Response to An Bord Pleanála Pre-application Consultation Opinion Ref. ABP-308497-20

Proposed Strategic Housing Development, 'Kenelm' Deer Park, Howth, Co. Dublin

Client	GLL PRS Holdco Ltd.		
Project Title	Kenelm SHD		
Document Title	Response to ABP Pre-application Consultation Opinion		
Document No.	3865		
Prepared by	PG	Checked by	JK

FIGURE 1 PERMEABILITY PLAN (EXTRACT FROM LANDSCAPE DESIGN STATEMENT)

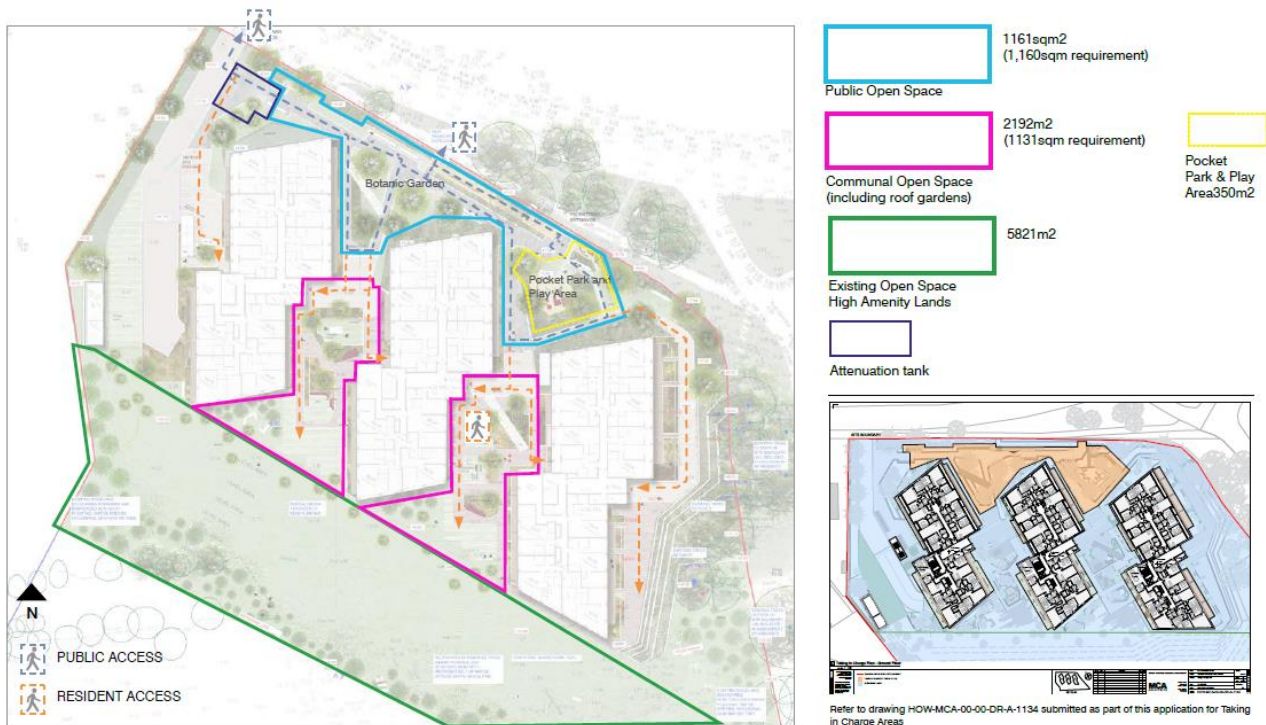
(iii) permeability plan of the proposed open space within the site clearly delineating public, semi-private and private spaces, areas to be gated, treatment of interface areas and provision of future connections to adjoining lands.

A permeability plan is included in the **Landscape Design Statement** that accompanies this application under separate cover and is reproduced below.

The proposed layout does not include gates. The open space is designed without any hard boundaries to allow free movement throughout the space allowing the visitor to take their own journey towards a planting area of particular interest.

The site is currently enclosed, and it is proposed to facilitate permeability from the adjacent public road by providing 2 no. openings in the northern demesne wall. Both will allow pedestrian/cyclist movement.

The feasibility of providing a future connection through the demesne wall to the east of the site was considered and discounted as;

- a) It would potentially affect the setting of the protected Castle gates.
- b) This area is occupied by mature woodland and development is intentionally stepped back from this area to protect the integrity of the trees. Works to the wall to facilitate a connection at this location could conflict with root protection areas.

To the south of the application area, it is proposed to plant a woodland hedgerow to delineate the site from the golf course beyond. Rather than formalise a possible future connection, which would have a negative effect on the total habitat area and potentially give rise to obstacles to the hedgerow performing its primary function, as a corridor for wildlife. It was decided that future connections at this location could be facilitated by informal gaps in the hedgerow.
